MANDATORY BULLETIN No. L 23/002a

Effectivity: L 23 Super-Blanik glider, serial number 897501-897520 and 907601-907614.

Description: A change of the lower tail skid suspension and the reinforcement of the fuselage in the place of the attachment in accordance with the next text of the bulletin.

1

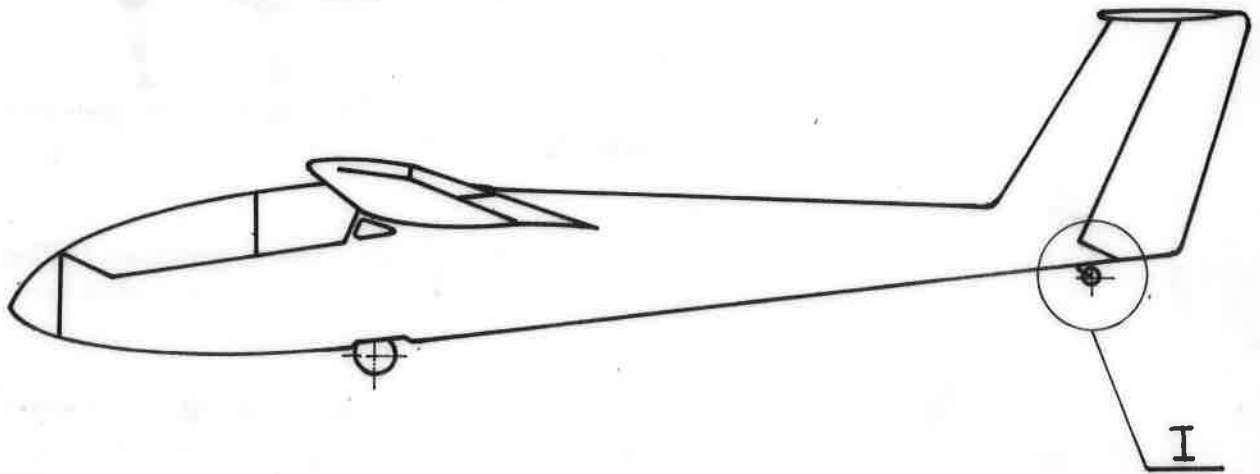
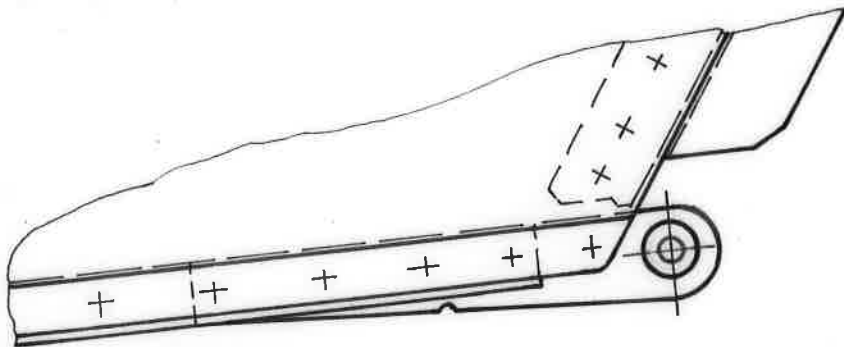
Reason: Failures at the rear of a fuselage in the place of tail skid attachment may appear within careless handling of a glider on earth surface.

2

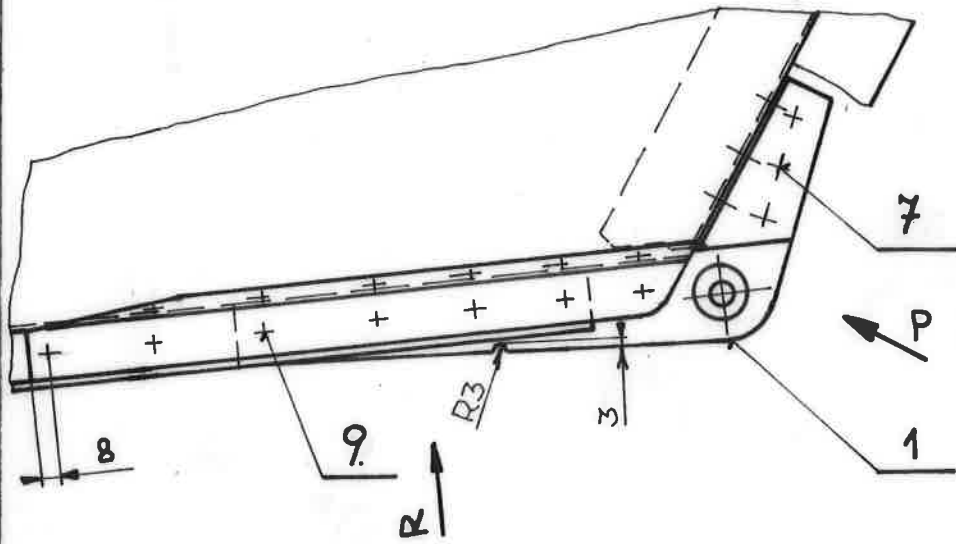
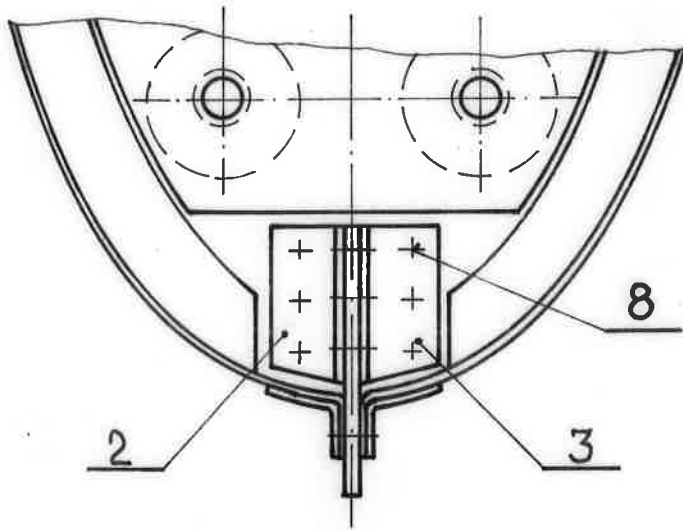
4. Drill 5 rivets holding a suspension and remove them, then drill next two rivets in front of the suspension.
5. Insert and assemble a new suspension (item 1) according to Fig.2. Install angles (items 2 and 3) and mark their positions with regard to the suspension. In case that angles are located by their edges at the reinforcement of the partitions, file the angles. Remove the suspension, install the angles to the suspension, drill with the \varnothing 3.5 mm borer and insert rivets (item 7).

7. Insert a suspension with riveted angles (items 2 and 3), assemble the left angle (item 5). Drill with a \varnothing 3.6 mm borer 6 holes for rivets (item 8) (Fig.2, view P) and 7 holes for rivets (item 9) (Fig.2, lateral view). Drill 6 vertical holes for rivets with the same pitch and an edge distance of 8 mm with a \varnothing 3.1 mm borer (item 10) (see Fig 3, view P)
Remove the left angle (item 5), put the right angle (item 6) and drill holes for rivets according to the procedure described above (items 9 and 10).

9. Reassemble the suspension and riveted angles, the angles 5 and 6, and assembly rivets (items 8, 9 and 10), consecutively.
10. Measure a distance of 400 mm from the levelling point No.6 and file a groove at the suspension according to Fig.2
11. Dismantle the ^{pull} draw rod of tail skid and replace with a new ^{pull} draw rod (item 4) in accordance with Fig.4.
12. Reinstall the tail skid and the cover.
13. Reinstall the boards a connect the instrument of PITO system .Check the leakage of ^{Manual} the PITO system in accordance with "The Operating Handbook, chapter 34"

3

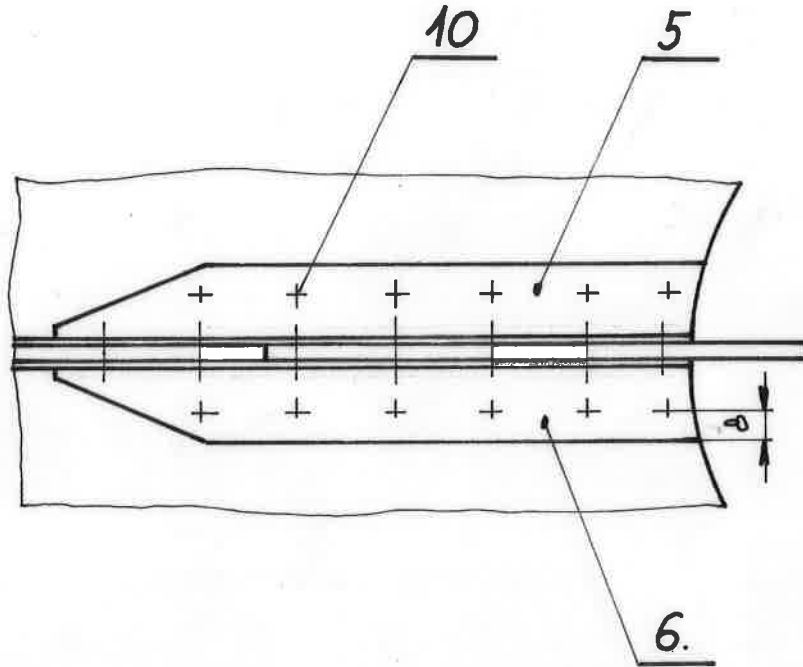
6. Assemble angles at the fuselage according to Fig.3 (items 5 and 6)so that the front edges of angles are 8 mm in front of the first hole of a drilled rivet (the seventh rivet from the end of fuselage, see Fig 2). Cut off the lengths of angles according to the last fuselage partition.
